Memorandum

Date: 28 April 2020 **Project:** 17001

Subject: Information for DEQ Regarding HydroAnalysis Technical Memorandum

Figure 1
Pre-1940 Schematic Profile of Burgard Area

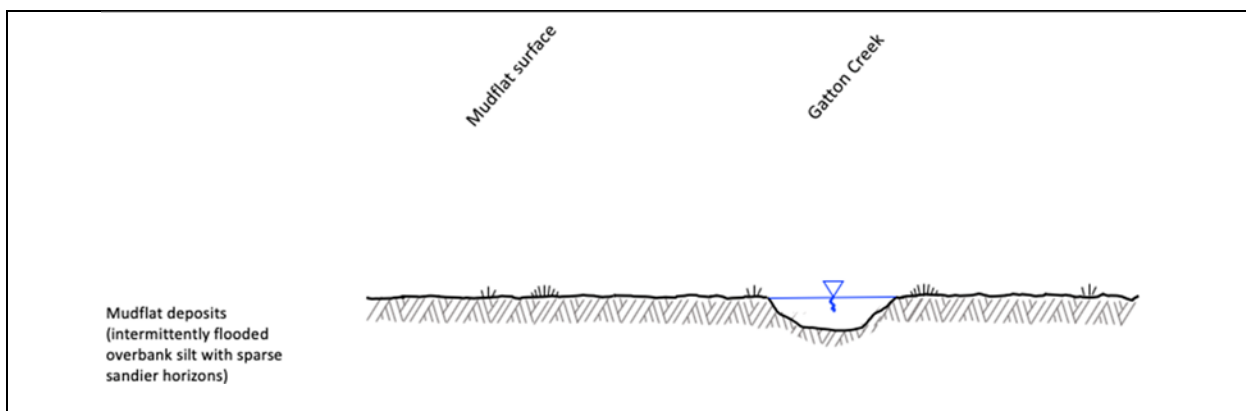
Preferential Pathway. HydroAnalytics' comment 9 suggests that a preferential pathway for groundwater and contaminant flow may exist associated with the former Gatton Creek, which is mapped as having flowed through the area prior to filling and industrial development.

When the question of the former Gatton Creek first arose, the Northwest Pipe project team evaluated its potential significance in the context of groundwater flow and contaminant migration. To do that, we considered the situation that existed before hydraulic fill was placed at the site to facilitate industrial development for WWII government production. This is shown schematically in Figure 1.

Based on the topography of the area, which consisted of flat, floodplain overbank deposits with standing water mapped in several parts of what is now the Burgard industrial area, it is reasonable to assume that Gatton Creek would have been a slow-moving stream, possibly meandering over time, with limited sediment carrying competence. This is supported by historic topographic maps showing several areas of “wetland” near Gatton Creek. For example, Dunne and Leopold¹ note that the grain size of sediment in a stream bed tends to decrease along the flow path, with coarser materials in the upland, hilly or mountainous reaches, to medium-grained materials in the middle section, to finer sand or silty sand further downstream. The Northwest Pipe site is close to Gatton Creek’s mouth at the Willamette River. Accordingly, the stream bed material of Gatton Creek would likely have been composed of silt and fine sand, since slow moving water flowing across relatively flat ground would have insufficient velocity to carry coarser material such as coarse sand and gravel. In short, it is not likely that the streambed material of a creek such as Gatton Creek would have contained coarse, high-permeability sediment in the Northwest Pipe/Burgard area.
